20-COA-0190
1228 S. 6th St.

Old Louisville Architectural Review Committee
Public Hearing

Bradley Fister, Historic Preservation Specialist
October 14, 2020

Request

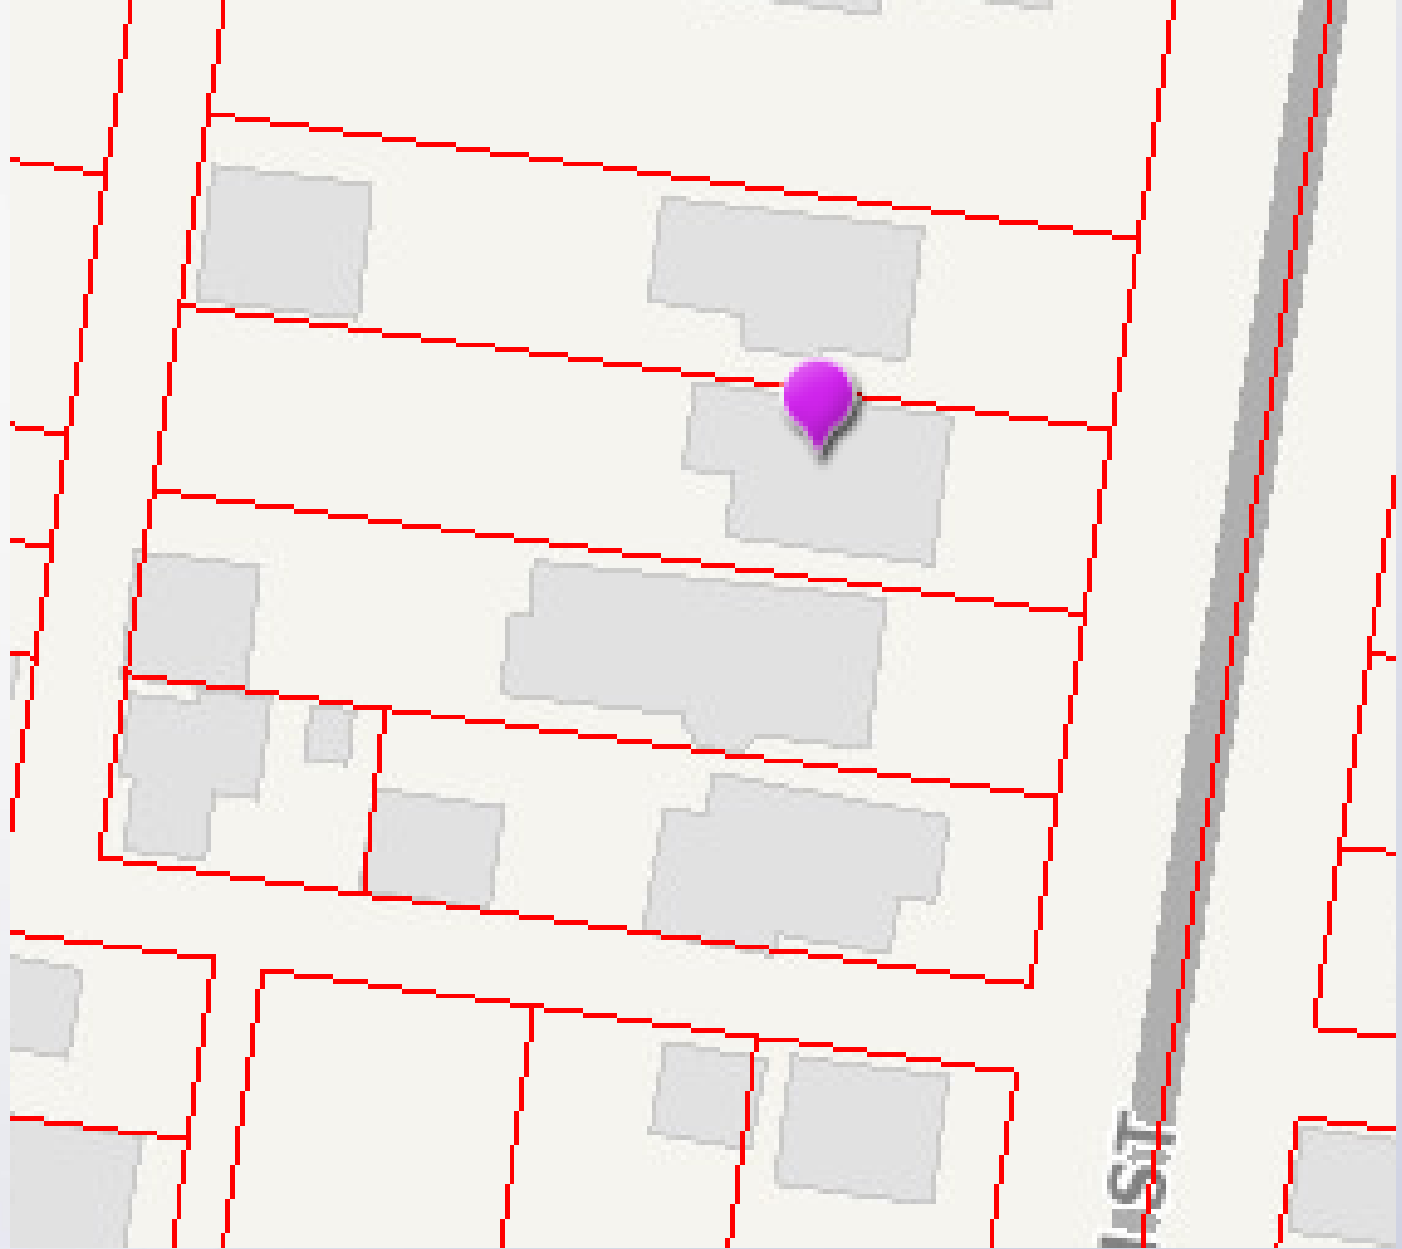
- Remove the existing two ganged double-hung windows in the gabled dormer on the front façade, and replace them with a ganged set of three casement style windows with a diamond patterned mutton configuration.

Existing with
replaced 1/1 DH
windows →

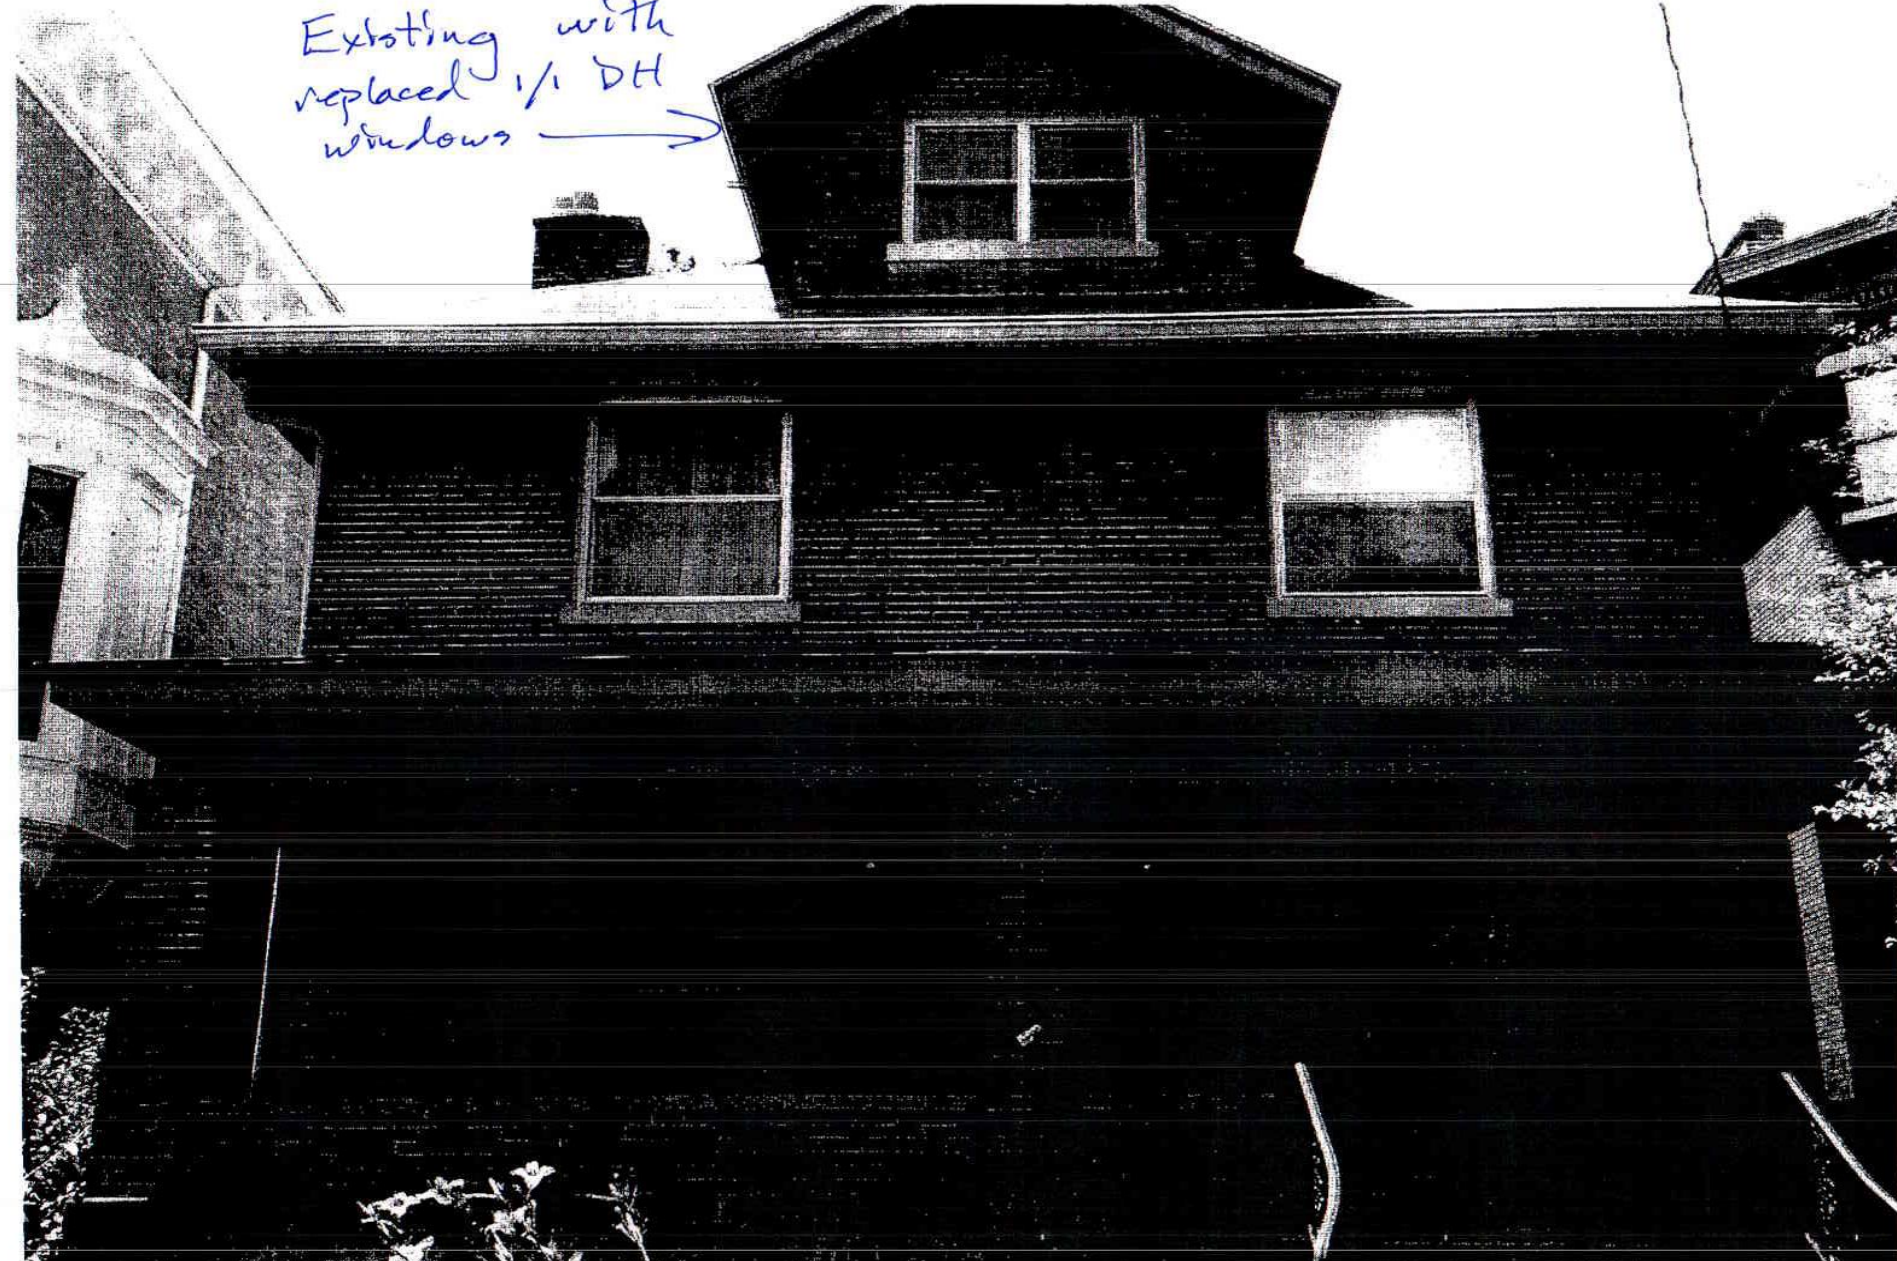
The proposed window replacement generally does not meet the design guidelines for **Window**. The windows that are proposed to be replaced appear to be replacement windows from circa-1950. Though the windows appear to have been replaced previously, they do match the one-over-one double hung pattern seen on the first and second-story front windows.

The proposed windows will be wood, however they are not proposed to be double-hung which is the style of the existing windows.

Per **W2** replacement windows should match the historic sash dimension, muntin configuration, reveal depths, glass-to-frame ratios, glazing patterns, frame dimensions, trim profiles, and decorative features when repair of original windows is impossible. The opening for the window would also be altered to allow for a ganged grouping of three casement style windows with a diamond mutton pattern which is not in conformance with **W4**.

This window design guideline states to not use a replacement sash that does not fit historic window openings. The proposed replacement windows are also in contradiction to **W7** which states that replacement windows operate in the same way as the original windows. The applicant proposes to replace double-hung windows with casement windows.

The proposal to replace the two existing windows with three is in contradiction to **W14** which states not to alter the number, size, location, or shape of original windows seen from a public way by making new window openings.

On the basis of the information furnished by the applicant, the application for a Certificate of Appropriateness is recommended for **Denial**, however if the Committee were to find the changes appropriate, staff recommends the following conditions:

1. The replacement windows shall fit the existing opening.
2. If the design changes, the applicant shall contact staff for review and approval.
